Preliminary Consultation
MONTGOMERY COUNTY HISTORIC PRESERVATION COMMISSION
STAFF REPORT

Address:	113 Elm Avenue, Takoma Park	Meeting Date:	4/22/2020
Resource:	Contributing Resource Takoma Park Historic District	Report Date:	8/15/2020
Applicant:	Brian and Catie Rowland (Eric Saul, Architect)	Public Notice:	4/8/2020
		Tax Credit:	No
Review:	Preliminary Consultation	Staff:	Dan Bruechert
PROPOSAL:	Partial demolition, new roof, rear addition, and other alterations.

Figure 3: 1959 Sanborn Fire Insurance Map showing the subject property with its expanded rear.

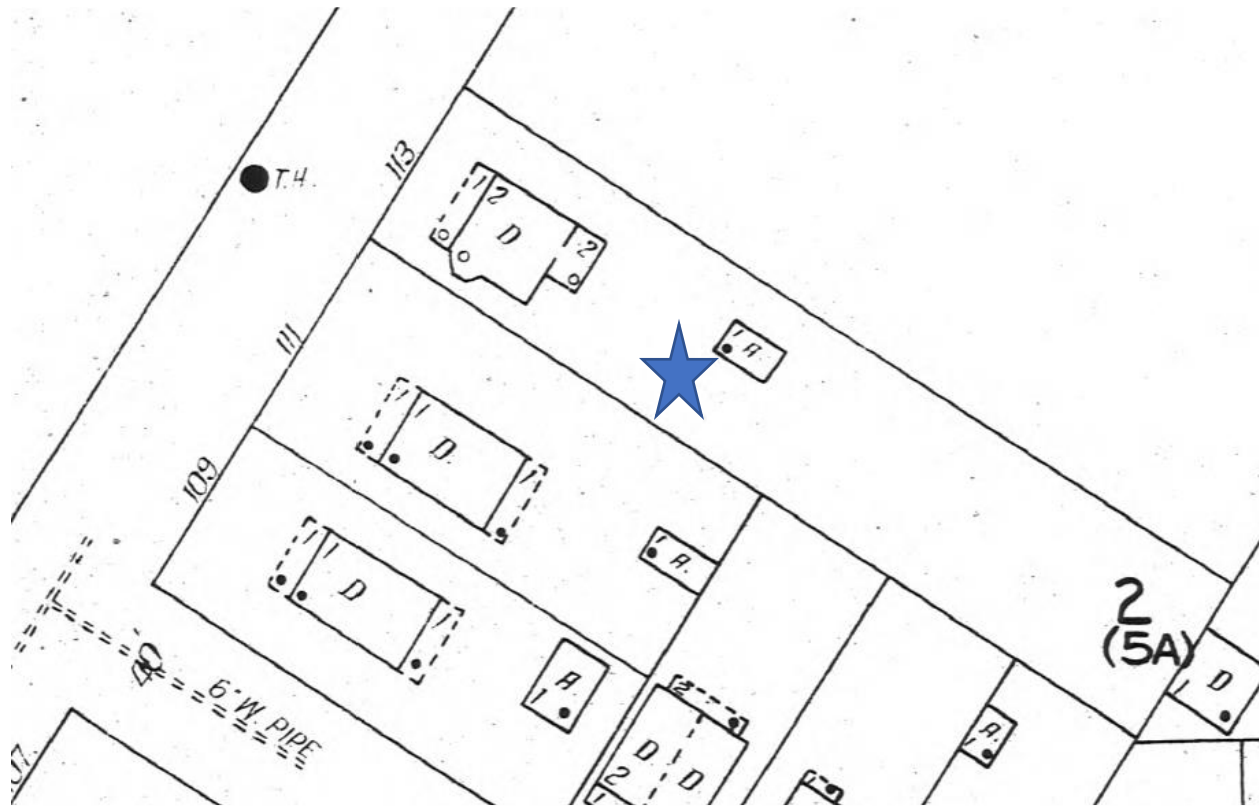
As shown in the Sanborn Maps, above, the rear of the house has been expanded from its original form. The exterior wall treatments match the house with stucco on the ground floor and siding on the second floor. The windows in the rear are a mix of sash (both two-over-two and six-over-six) and casements. The rear door is a half-lite wood door. There was a rear stoop that has been removed.

3 PROPOSED SIDE (EAST) ELEVATION
A2 1/4" = 1'-0"

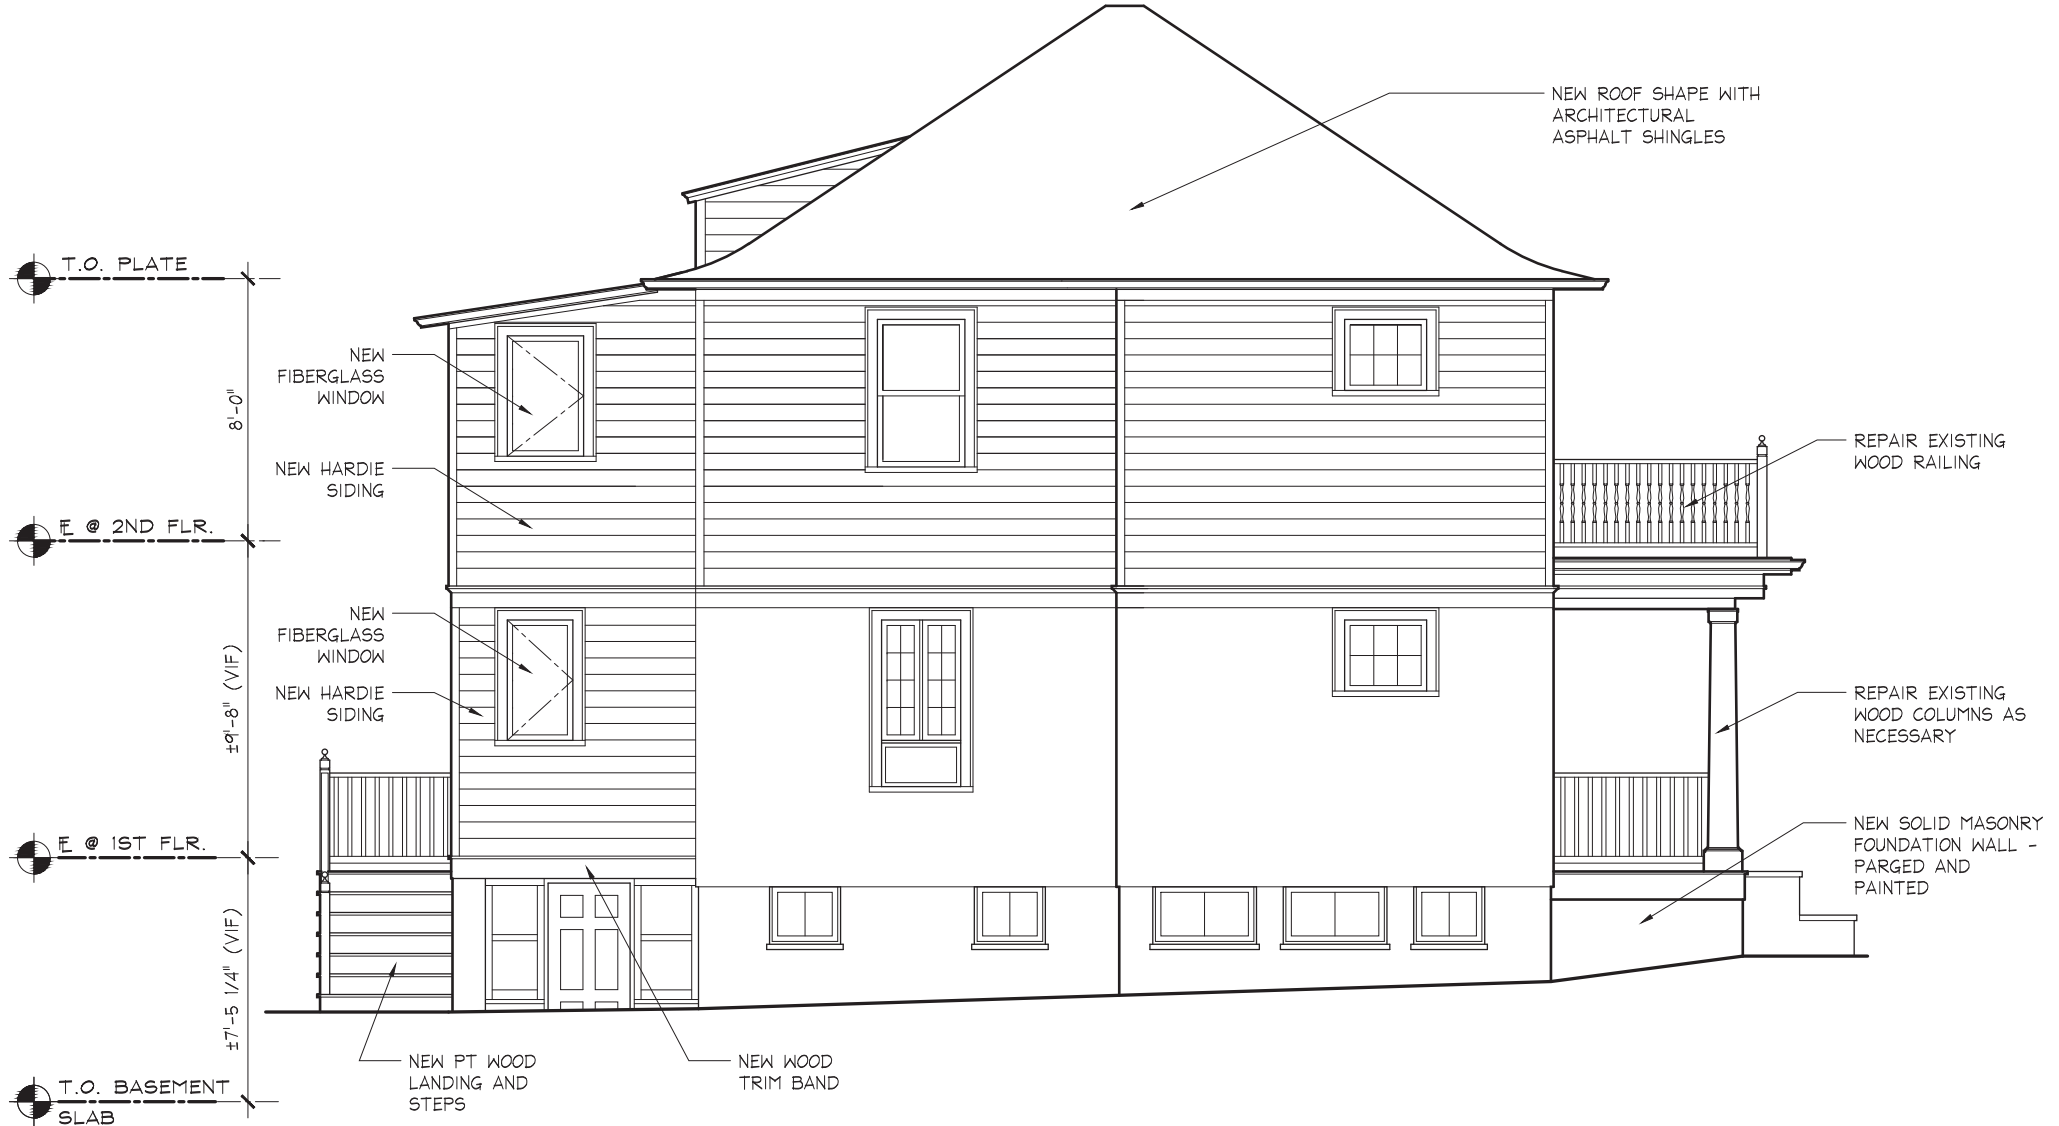
The alterations to the left (east) elevation will be visible from the right-of-way. The proposal will replace a pair of six-over-six sash windows on the first floor and two fixed single-lite windows on the second floor, with a single-lite casement window on each floor. Staff finds that the appearance of the left elevation, with five different window types, will only have four different windows after the proposed work. Staff finds that a more compatible design solution for the left elevation would be installing one-over-one sash windows in the rear in place of the proposed casements. This revision would result in only three different window configurations on the left elevation as the sash windows would match the central second-floor window. Staff recognizes that the proposal will simplify the elevation, but request feedback from the HPC as to the appropriateness of the proposed casement windows.

1
A2 PROPOSED FRONT ELEVATION
1/4" = 1'-0"

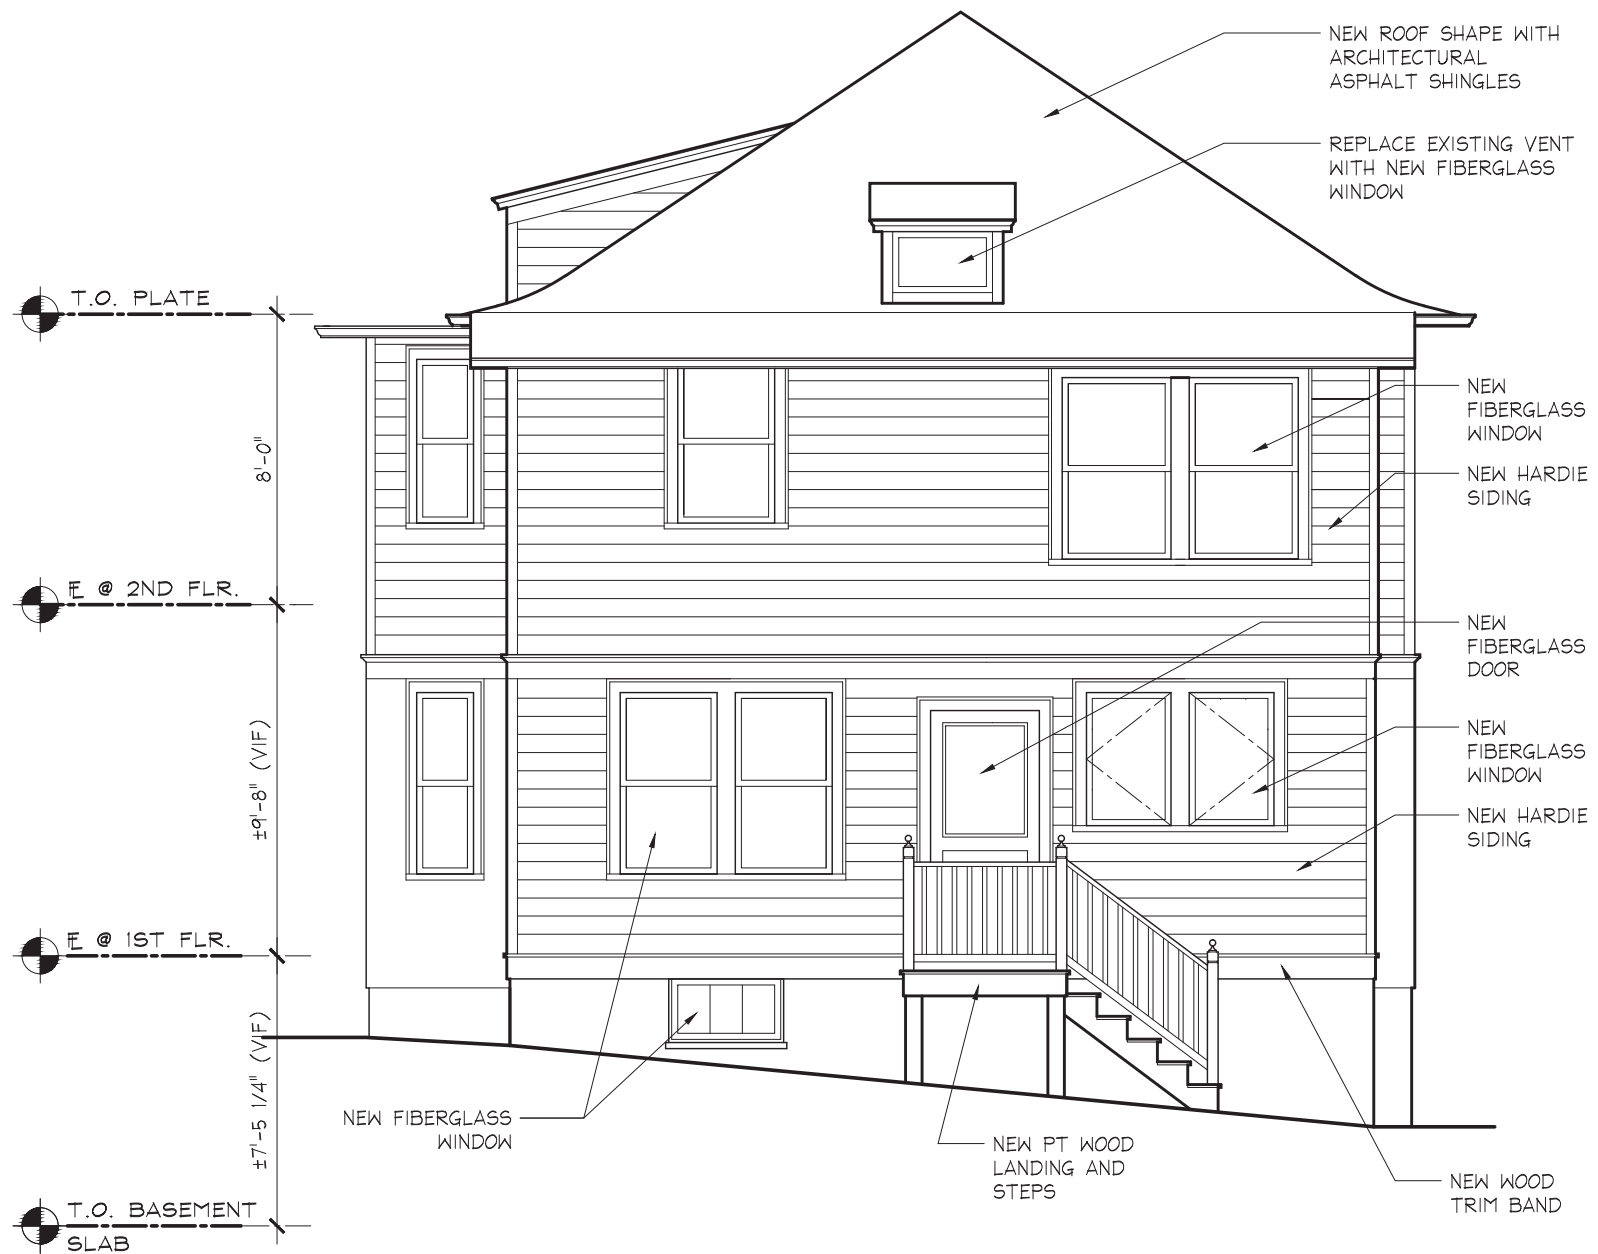
The applicant proposes to remove the existing roof and construct a more regularized, pyramidal roof with a central peak. The new roof will retain the flared eaves. The rear shed dormer will be retained and a window is proposed for the existing attic vent. The submitted materials only identify the window as a ‘fiberglass window.’

The roof reconfiguration will alter the appearance of the house when viewed from the public right-of-way. However, the current roof configuration and its inability to effectively control water continue to cause damage to the house and the long-term survival of the historic house appears to be better served by allowing the change (per 24A-8(b)(3)). Because window specifications were not included with the submitted materials, Staff cannot provide a complete analysis for the proposed attic window. Staff finds that converting the vent to a window is an acceptable alteration as this change is at the back and appears to match the size of the vent. Additionally, in the Takoma Park Historic District, window replacements on the rear or new construction have frequently accepted aluminum-clad wood windows as an acceptable substitute for traditional wood windows. However, without material specifications and profiles, Staff cannot provide any feedback on the proposed window.

Staff finds that a parged and painted porch foundation will not significantly alter the character of the house and would recommend approval as a HAWP.

2 PROPOSED REAR ELEVATION
A2 1/4" = 1'-0"

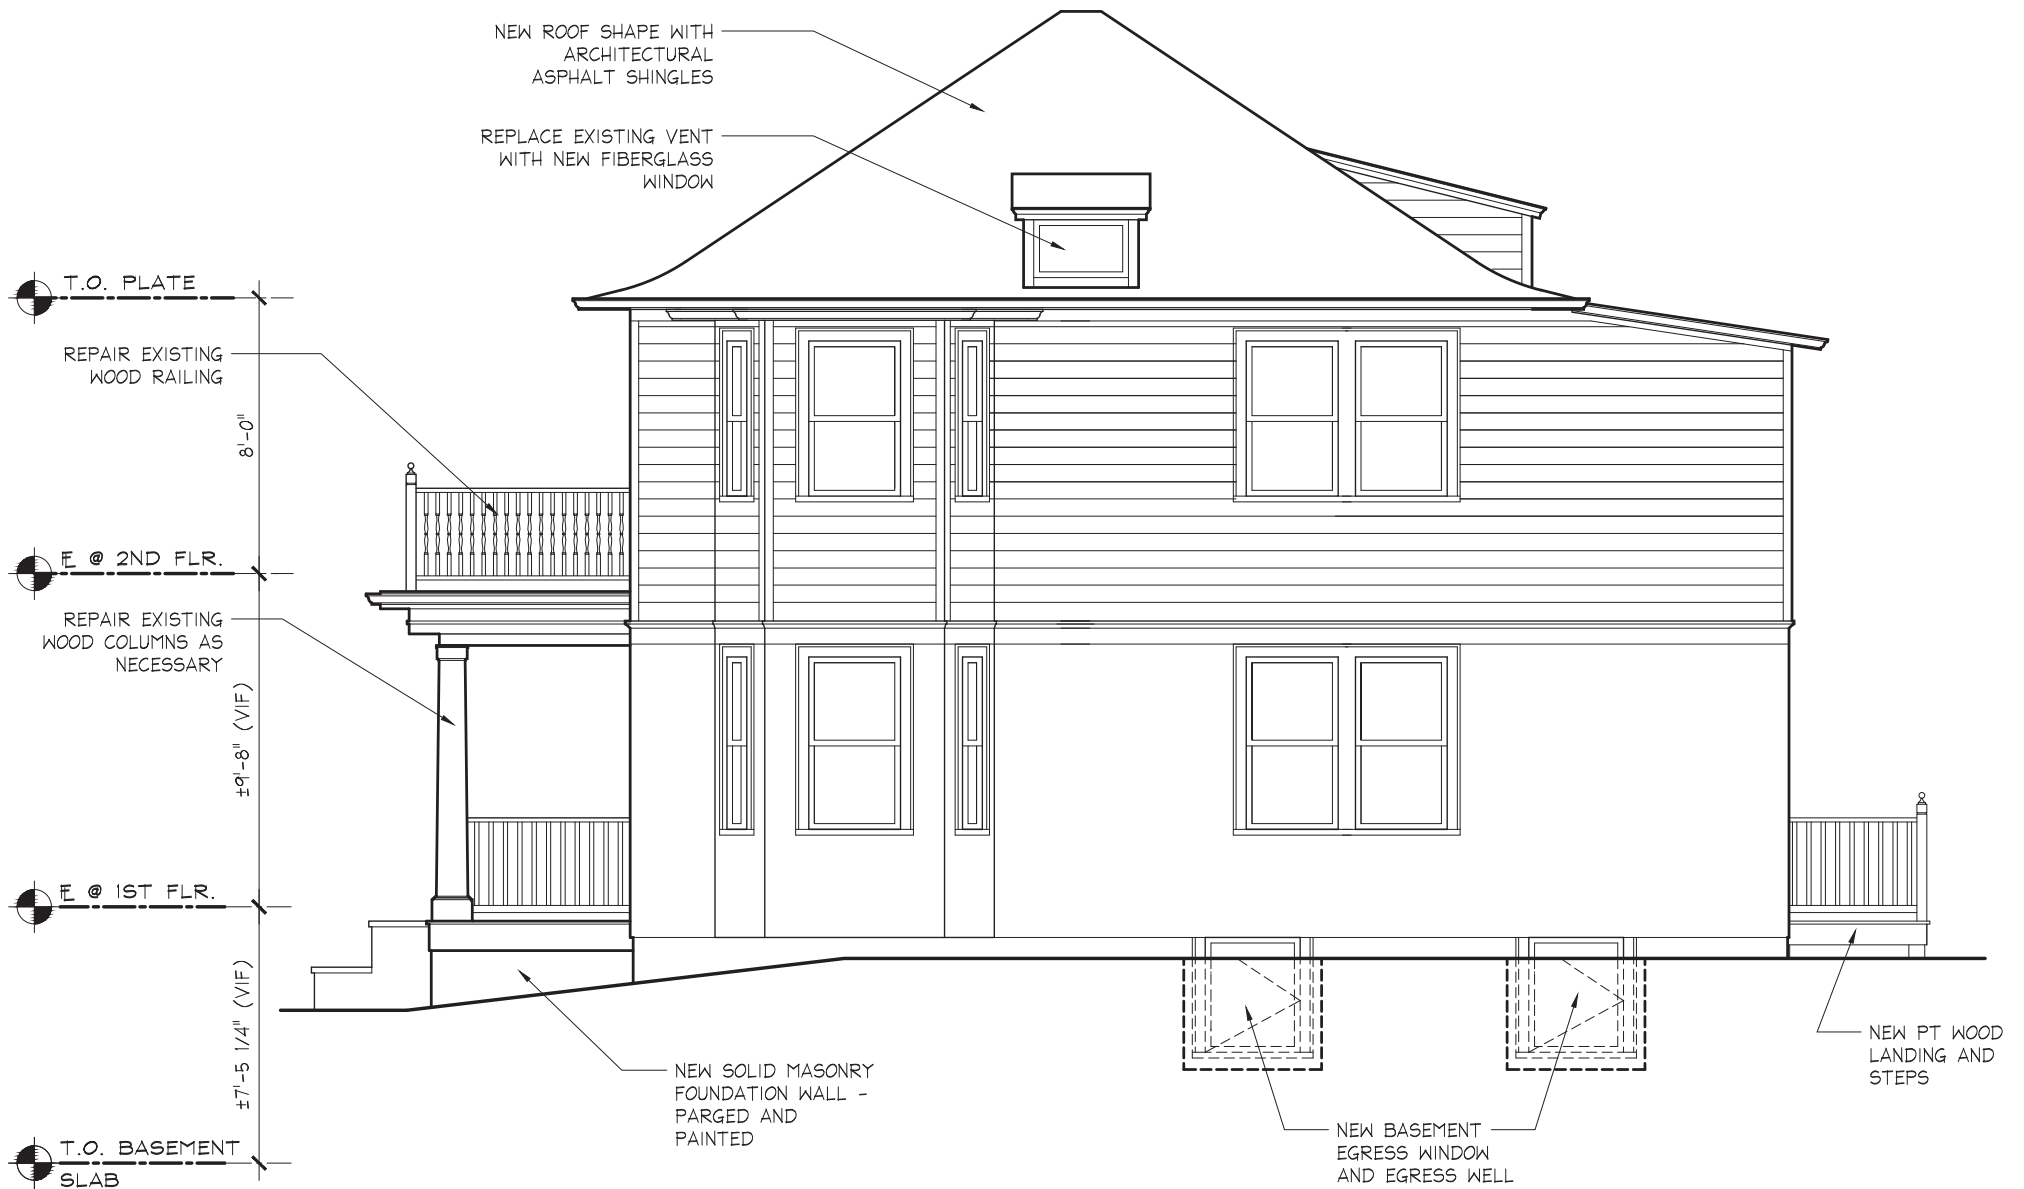
The applicant proposes altering the fenestration of the rear addition to accommodate a reconfiguration of interior spaces. The door will be moved closer to the center of the elevation with a new set of wood stairs. On the first floor, the applicant proposes a pair of sash windows to the left of the door and a pair of casement windows to the right of the door. On the second floor, the applicant proposes installing a single one-over-one sash window on the left of the elevation and a pair of one-over-one sash windows on the right. On the left (east) elevation, the applicant proposes installing a casement window on each floor. The material specified for the doors and windows is ‘fiberglass.’ Specifications for the windows and doors were not included with the submitted materials. Material specifications for the proposed windows and doors will need to be included for a complete HAWP application.

Staff finds that proposed fenestration reconfiguration is appropriate overall. The rear elevation has been altered from its historic configuration, so the proposed work will not significantly alter historic features. Additionally, most of the proposed work is on the rear, and will not be visible from the public right-of-way within the district, so evaluations of these changes should be judged leniently (24A-8(d)) and *Design Guidelines*.

Staff finds that the siding replacement at the rear would not have a significant impact on the character of the house or the surrounding district. Additionally, Staff finds that if the applicant proposed a new rear addition, the HPC would encourage some level of differentiation between the old and the new; and as the current appearance of the rear of the house is not its historic appearance, it would be appropriate to create that differentiation now. Staff would recommend approval of the siding alteration under 24A-8(b)(2) and (d).
